*Re: Application for Site Plan Review, 192 Millbury Ave.*

Attn: *Laurie Connors, Director*  
RE: *Peer Review for Site Development Plan at  
192 Millbury Avenue, Millbury, Massachusetts  
BEI Project No. 21M-170  
Mass DEP File No. 224-0826*

Bertin Engineering, Inc. (BEI), at the request of Fletcher Tilton, PC (FTPC) has performed a Peer Review of the site plans, project narratives and stormwater report for a site plan development located at 192 Millbury Avenue in Millbury, MA (Assessors Map 23, Lot 147, Business-II).

DEP FILE # CERO 224-0826 SHEET 2 OF 3  
 DESIGNED BY: R G Murphy DRAWN BY: R G Murphy DATE: 8-25-2021

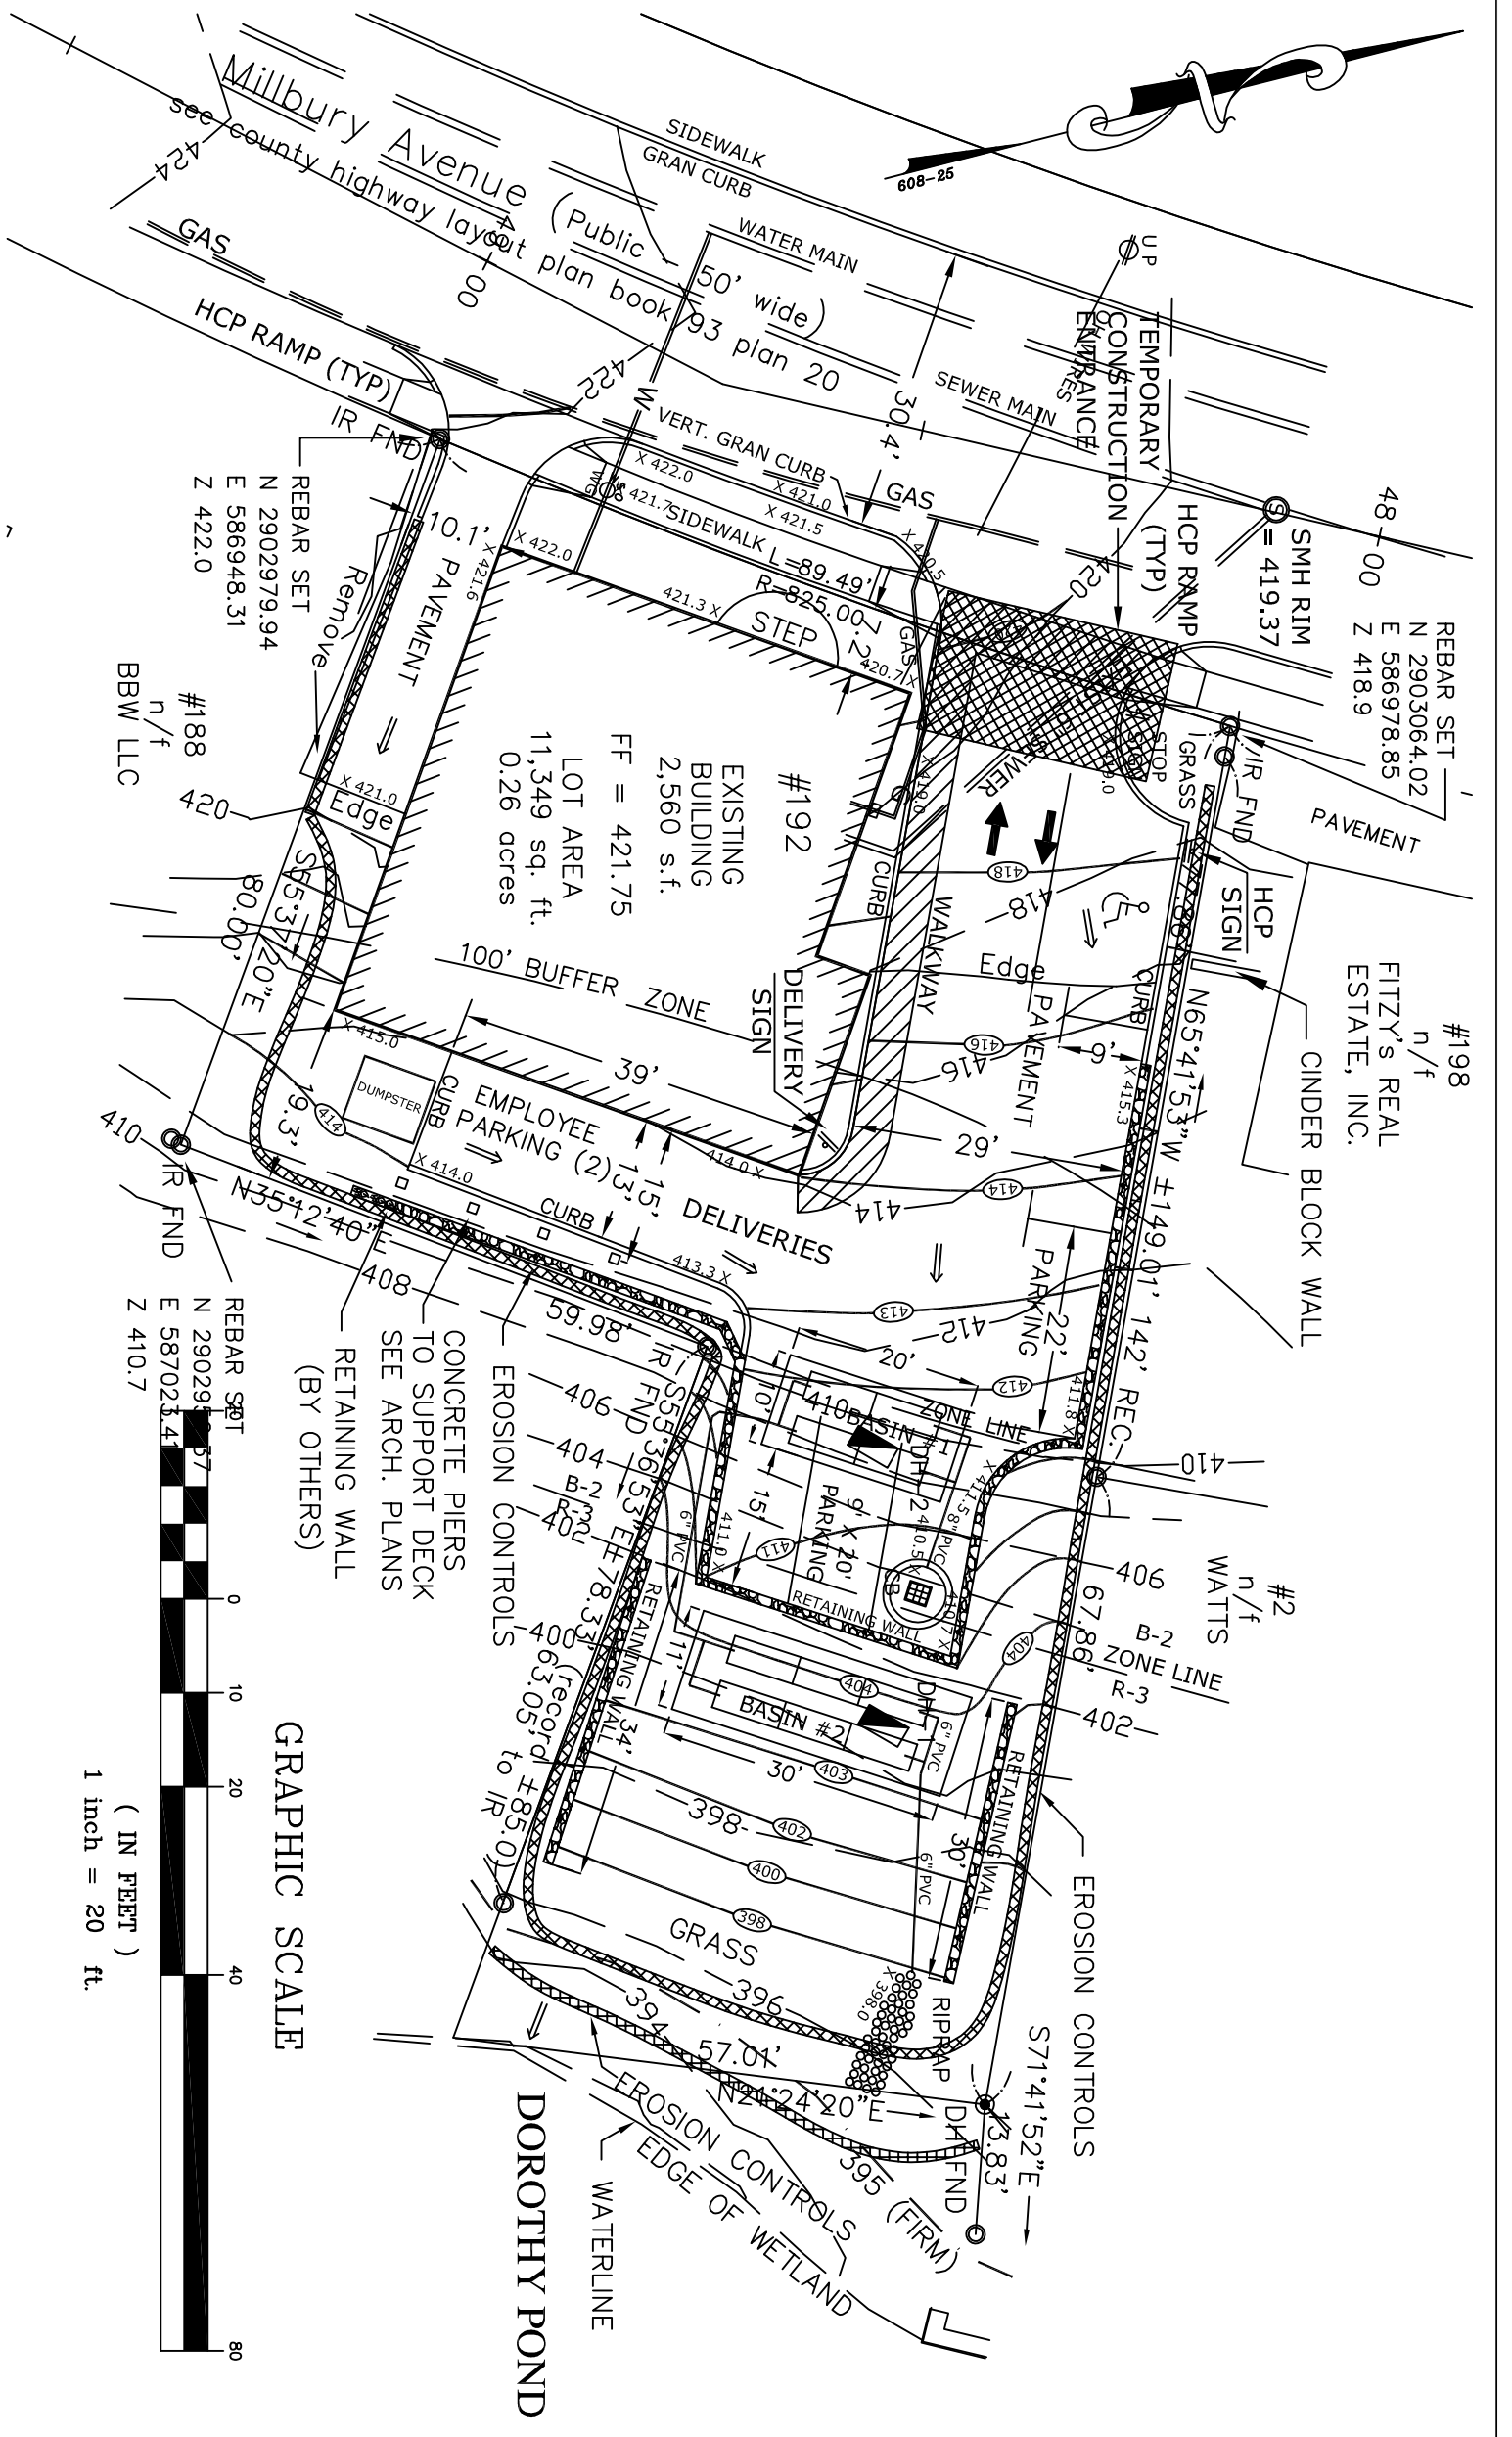
**BEI Comment 9:** 6.17.4 (a) -All drain pipes shall be at least twelve inches (12") inside diameter, made of High Density Corrugated Polyethylene (HDPE). It is unclear... why the RMA has specified 6 and 8-inch PVC for storm drainage piping on drawing sheet 1 and 2.

**Erosion and sedimentation control measures are identified on the Site Plans and further described in the submitted Stormwater Pollution Prevention Plan. A sequence of construction has been provided in the Stormwater Pollution Prevention Plan. We recommend the construction sequence be added or referenced to the Site Plan.**

**HDPE CULVERT-OUTLET DETAIL** N.T.S.

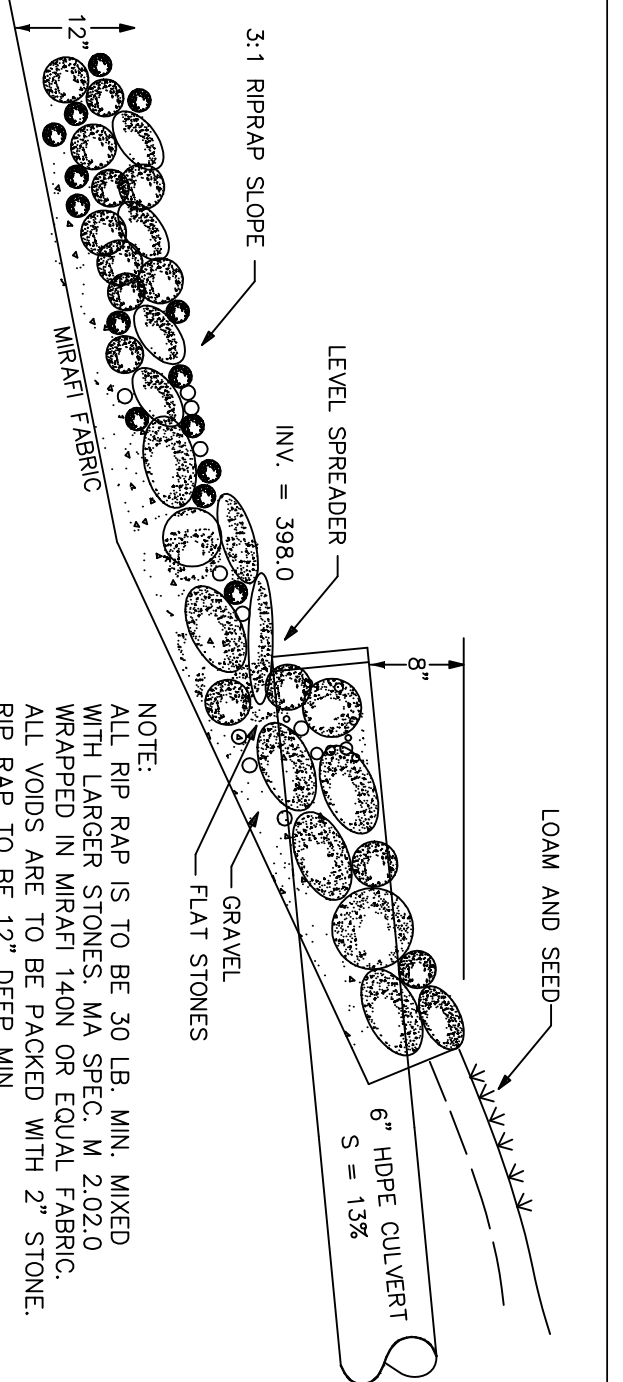
**BEI Comment 11:** 6.17.5 –BEI notes: that is unclear... what flow velocity will exit the pipe end, adjacent to Dorothy Pond. Construction details shall be prepared by an engineer and submitted to the Board for review and approval by RMA.

**LANDSCAPE PLAN**

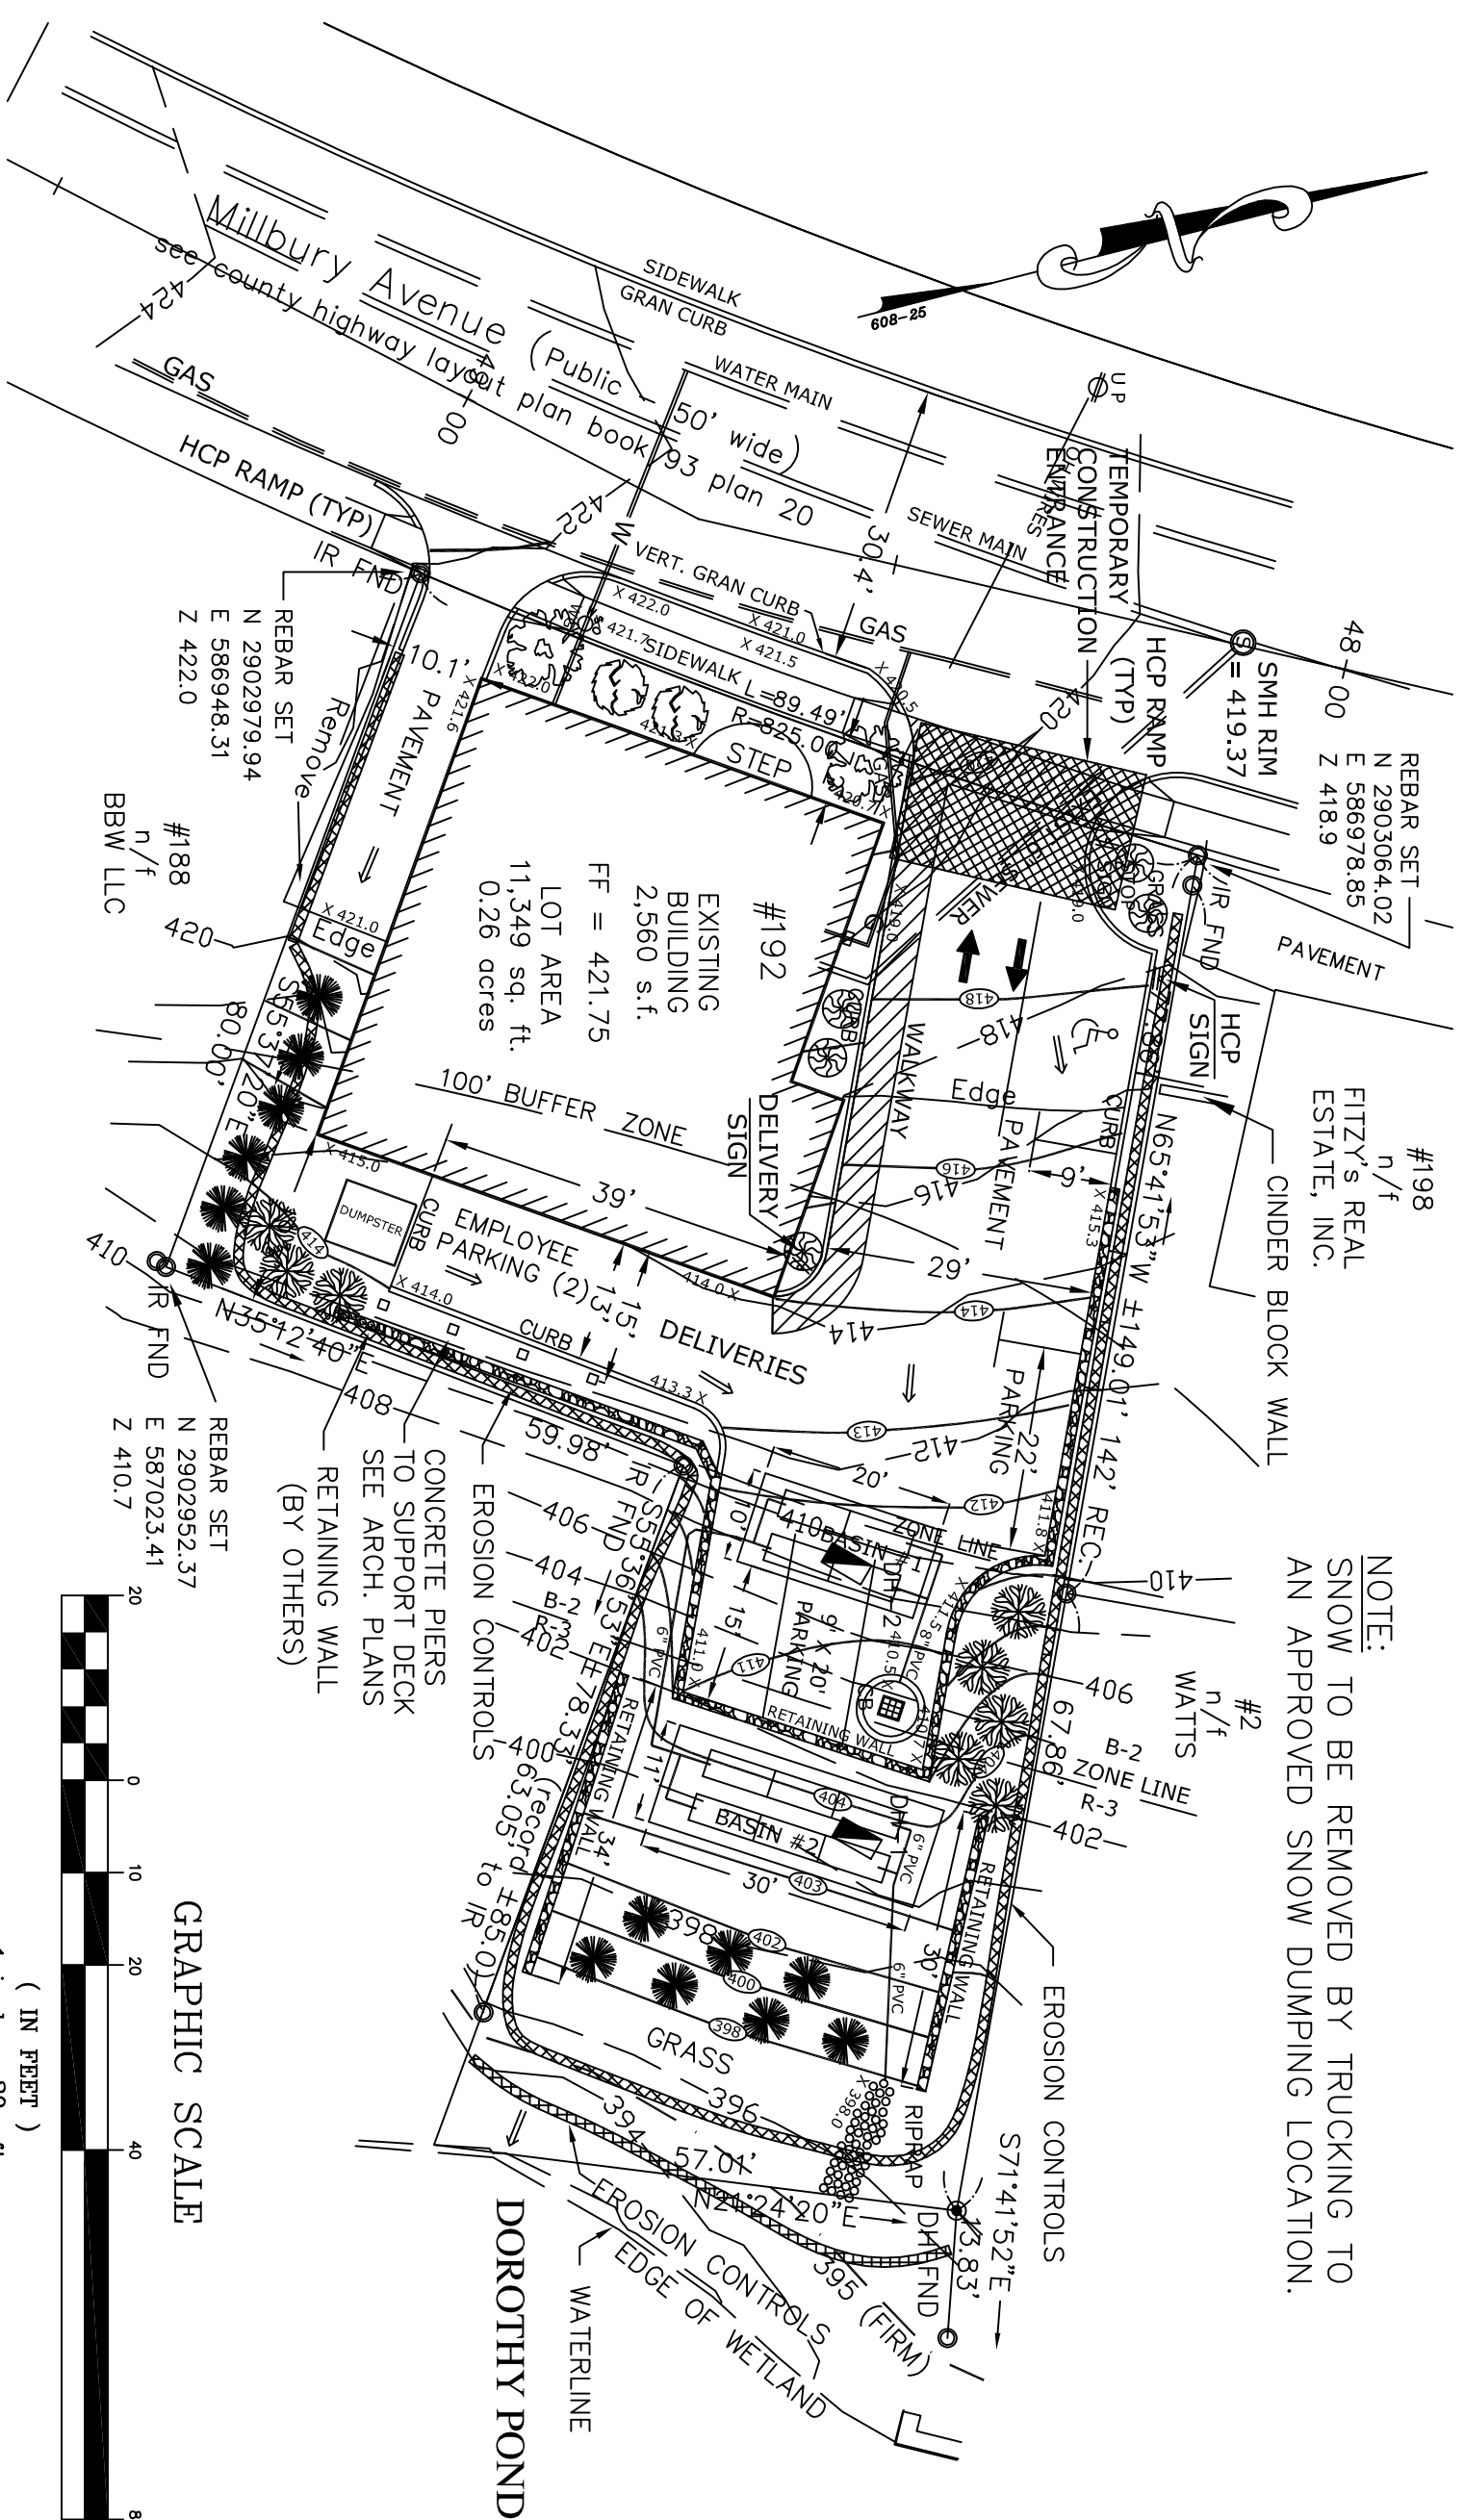
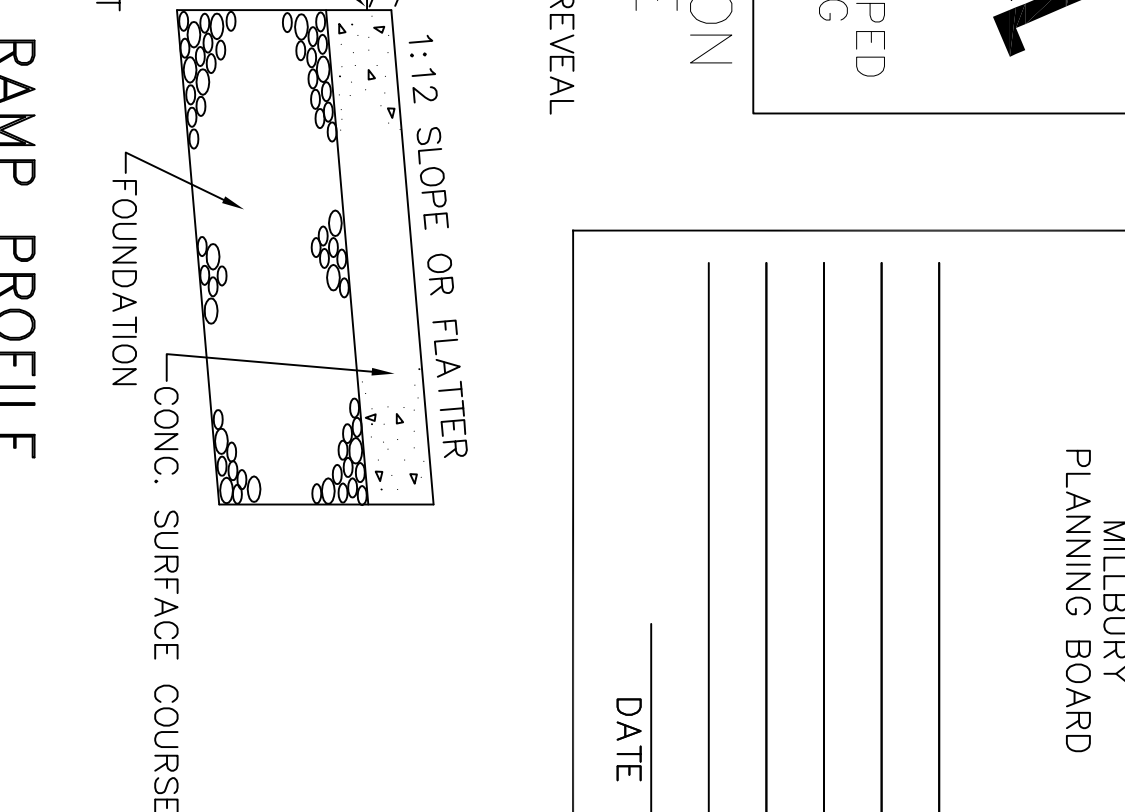
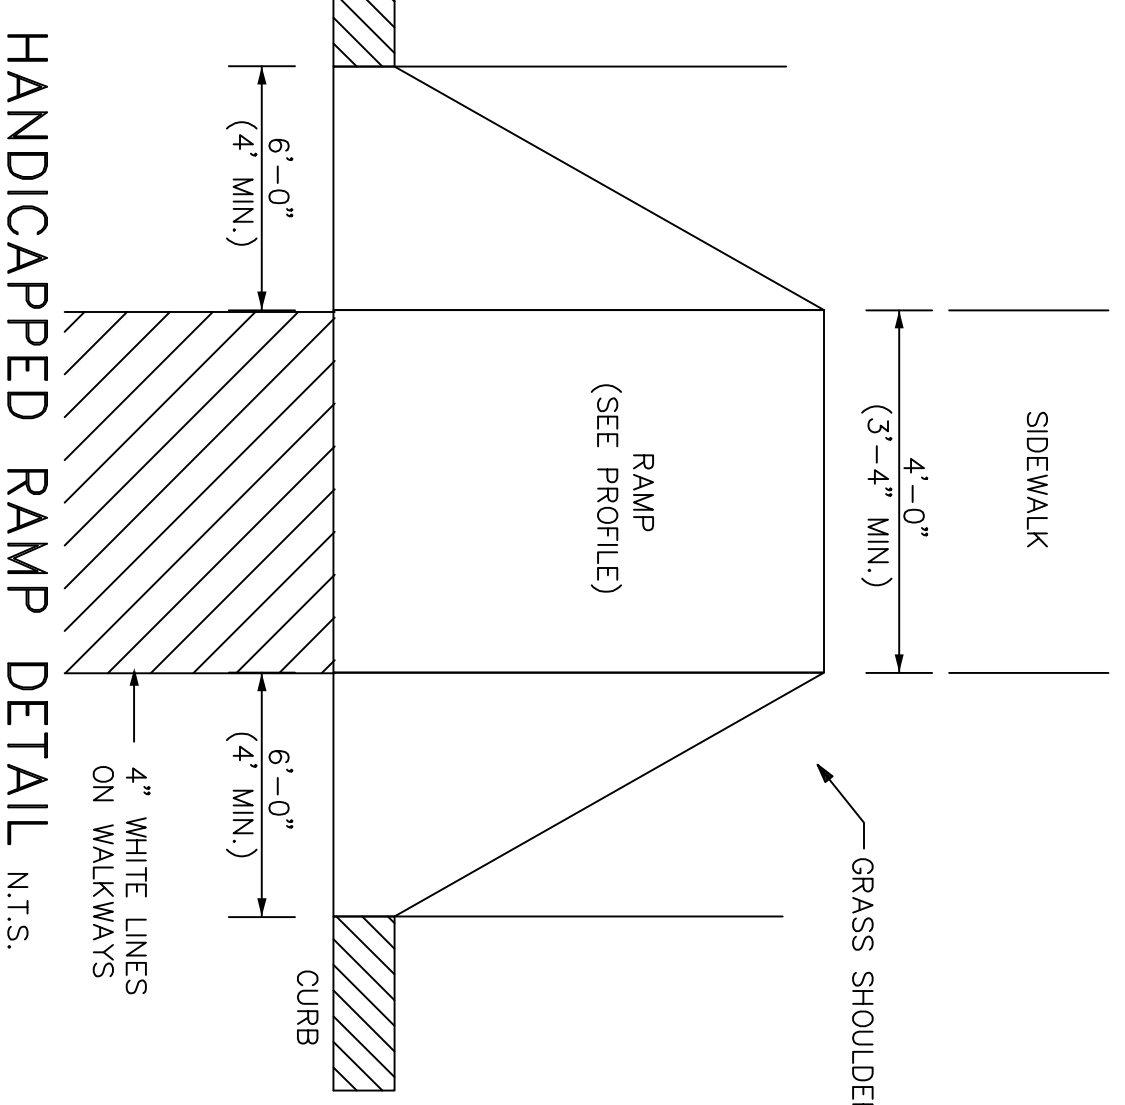
**BEI Comment 20:** 12.45 (s) The soil log locations are not labeled on the plan, which makes it difficult to discern if the standard is met.

6. Lighting and Photometric Plan was not provided with the Site Plan submission. We recommend this item be addressed by the applicant.
7. Parking calculations on sheet 3 of 3 identify nine (9) proposed parking spaces. Stantec recommends the applicant provide documentation to support the proposed number of parking spaces as required per Section 33. Parking and Loading Requirements. We also recommend pavement markings delineating the parking spaces be shown on the plan and provisions for handicap accessible spaces be addressed by the applicant.

1. Landscaping: As shown on sheet 3 of 3, proposed grading includes fills between 2 and 6 feet within the site. As such, retaining walls are proposed along the northerly and easterly property line in varied height between 2 and 5 feet. We recommend the applicant provide final designed stamp drawings of the proposed retaining walls and evaluate the need for a guard rail adjacent to the proposed parking areas. We note segments of the proposed retaining walls are approximately 2 feet off the property line and question the need for temporary construction easements from the abutting properties.

- Soil logs 1 and 2 have been provided on Sheet 3 of 3, entitled Landscape Plan. The seasonal high groundwater elevation has only been provided for both basin locations.
- Existing and proposed ground cover and runoff coefficients have been provided in the Stormwater Report.
- A drainage area map showing pre and post conditions have been provided in the Stormwater Report.
- A sequence of construction has been provided in the Stormwater Pollution Prevention Plan. We recommend the construction sequence be added to the Site Plan.
- Stantec recommend cross section of the proposed two subsurface chamber systems identifying items such as existing and proposed grades, refusal and/or seasonal high groundwater be provided on the plans.
- Provide calculations regarding the average annual load of Total Phosphorus and estimated pollution removal
